Modification Requests  
Concept Plan MP08\_0065 MOD2  
Project Approval MP08\_0066 MOD5

**Oakdale Central Industrial Estate, Horsley Park**

Figure 6: Approved and proposed location of stormwater basin

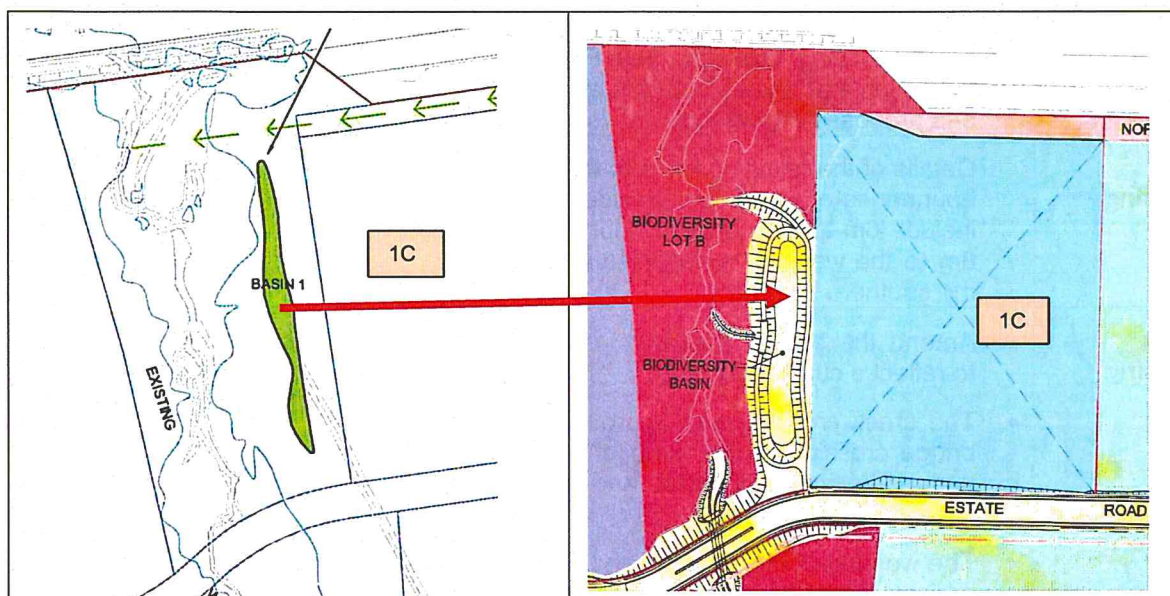
The widening of lot 1C for development means that the stormwater basin previously adjoining the riparian corridor is now moved closer to be partially within the outer riparian zone (ORZ). As approved, the stormwater basin was to be located in between the outer boundary of the riparian corridor of Ropes Creek and the boundary of lot 1C.

As stated, the stormwater basin relocation can be approved under the concept plan modification but construction cannot be approved under the project approval modification. The proponent will have to seek separate approval under Part 4 of the Act for the basin construction.

**Figure 12:** Stormwater basin outlets encroaching the E2 zone

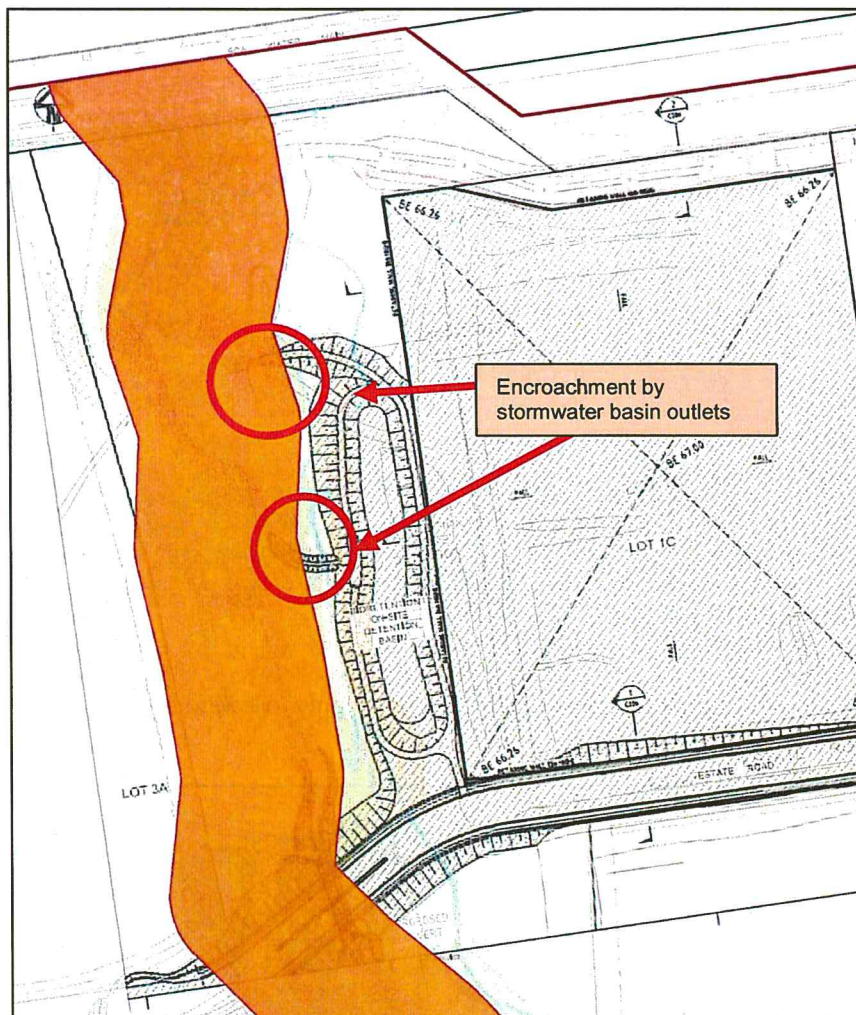
No issue is raised with the warehouse and distribution uses proposed in the IN1 zone. The works proposed in the E2 zone include environmental protection works, roads and the stormwater basin outlets. **Figure 12** shows the stormwater basin outlets encroaching the E2 zone.

Under the WSEA stormwater outlets are not permissible in the E2 zone. Therefore, the stormwater outlets (and by default the stormwater basin) cannot be approved for construction under the project approval by the department. The department could however, modify the concept plan to amend the location of the basin and outlets.

As discussed in section 6, the department is satisfied with the new location of the stormwater basin and outlets and recommends it be approved. An amendment to the concept plan approval is recommended in this regard. In order to enable the proponent to carry out the works, there are two options:

In this respect, the concept plan modification will approve the basin relocation but the project approval modification will not approve its construction and separate approval under Part 4 of the Act must be sought by the proponent.

**Figure 13:** Proposed location of stormwater basin in relation to riparian corridor (source Aecom)

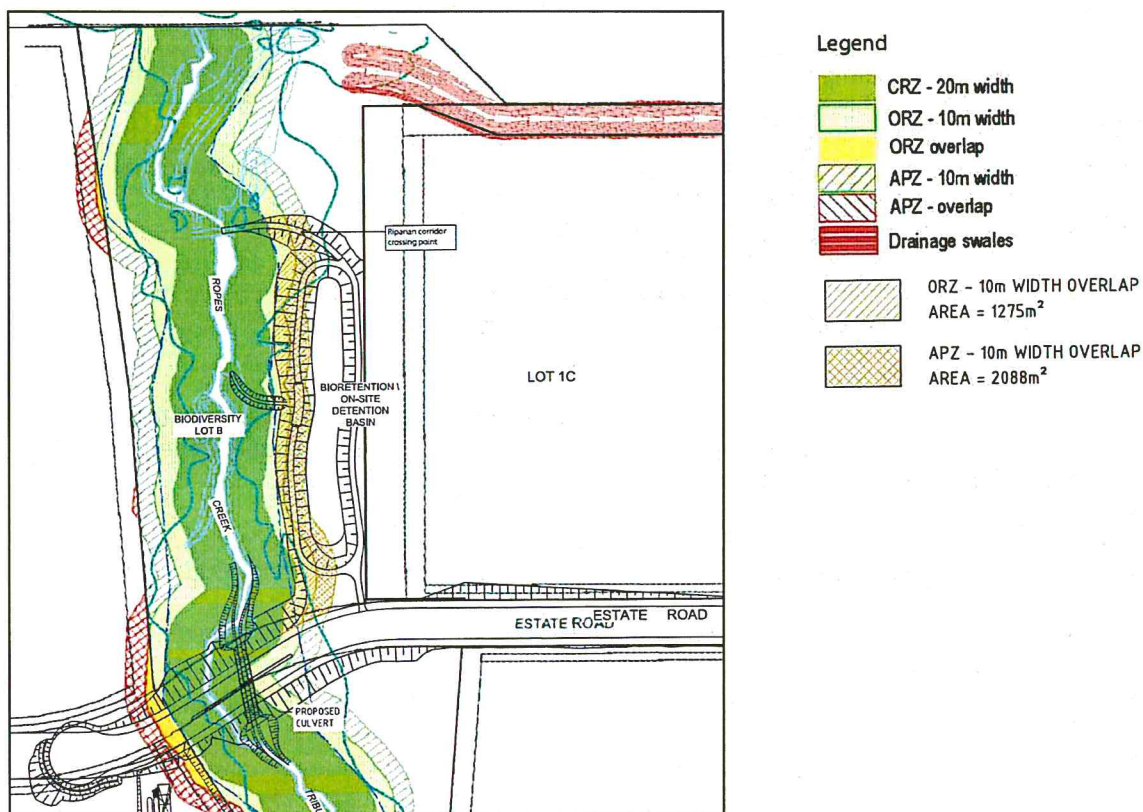
Concern was raised by NOW that the increase in lot 1C and the relocation of the stormwater basin should not compromise the approved riparian corridor widths and any offset areas.

The proposed location of the stormwater basin will now encroach 1,275m<sup>2</sup> into the ORZ. This can be seen in **Figure 13**. The riparian planting will now be partially located within the banks of the stormwater basin. This encroachment is considered acceptable by the department because the riparian corridor width and offset area are still maintained.

In discussions with NOW, the encroachment proposed is considered acceptable. This is because the total conservation land area of 4.6ha will not decrease and that part of the stormwater basin that encroaches into the ORZ will still be planted as a riparian corridor.

The proposed increase in lot 1C to enable flexibility for future tenancy requirements and the resultant decrease in biodiversity lot B and the relocation of the stormwater basin is considered acceptable by the department because the amount of conservation land will be retained at 4.6ha and the riparian corridor widths will be maintained with appropriate planting. All proposed plantings will be treated in accordance with the approved VMP.

Figure 14: Proposed culvert batter treatment (source Aecom)

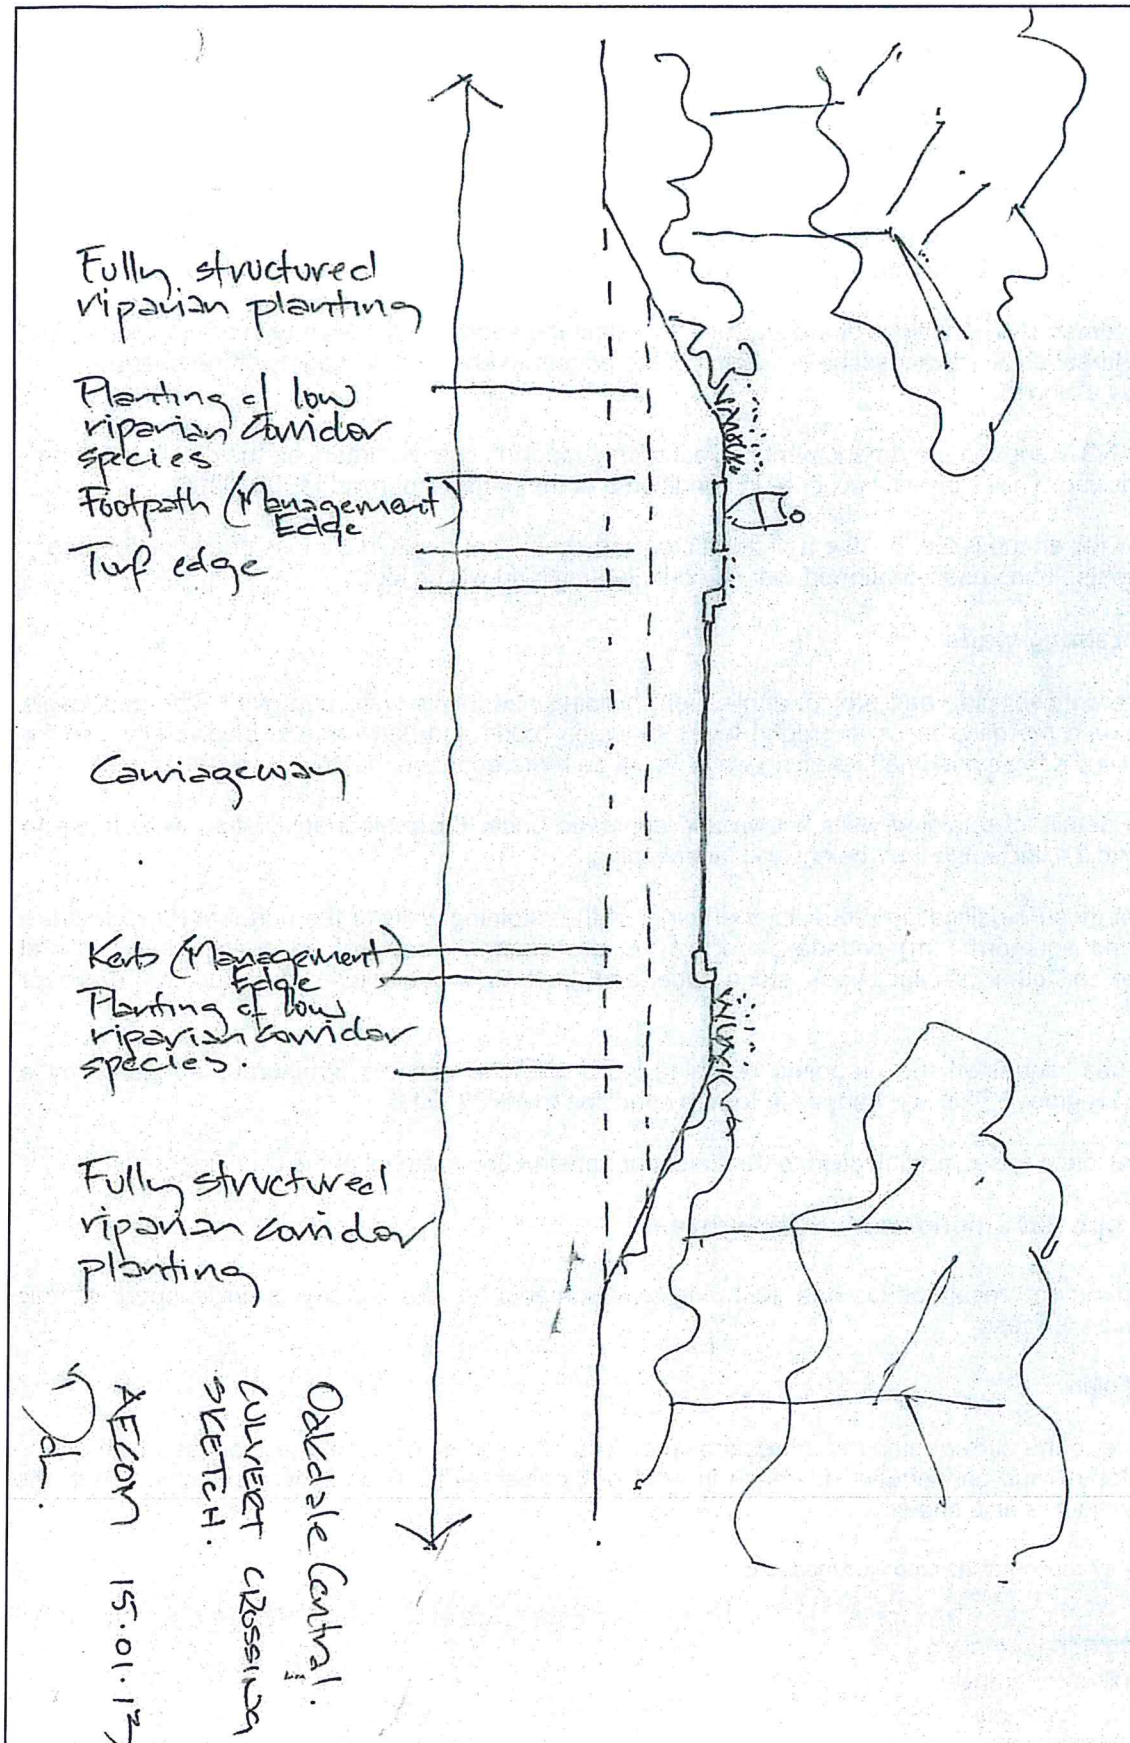
The batters to the road/ culvert crossing are currently shown as being grassed within the submitted landscape drawings rather than planted with riparian vegetation. These grassed batters encroach the riparian corridor as shown in **Figure 13**.

It is not ideal, as with the stormwater basin/ riparian corridor interface above, to have grass treatment adjoining the riparian planting. A management edge should separate grass from riparian planting.

Therefore, it is proposed to vegetate the batters as shown in the culvert section in **Figure 14**. From the riparian corridor edge, this would involve fully structured riparian planting, planting of low riparian corridor species, the footpath (management edge), turf and the carriageway. This would be mirrored on the other side of the carriageway.

This treatment is proposed to be included in condition 5 of schedule 3 of MP08\_0066. This condition requires the final design of the creek crossing to be provided to the Director-General, designed in accordance with the Department of Primary Industries (ie Fisheries NSW) and relevant guidelines.
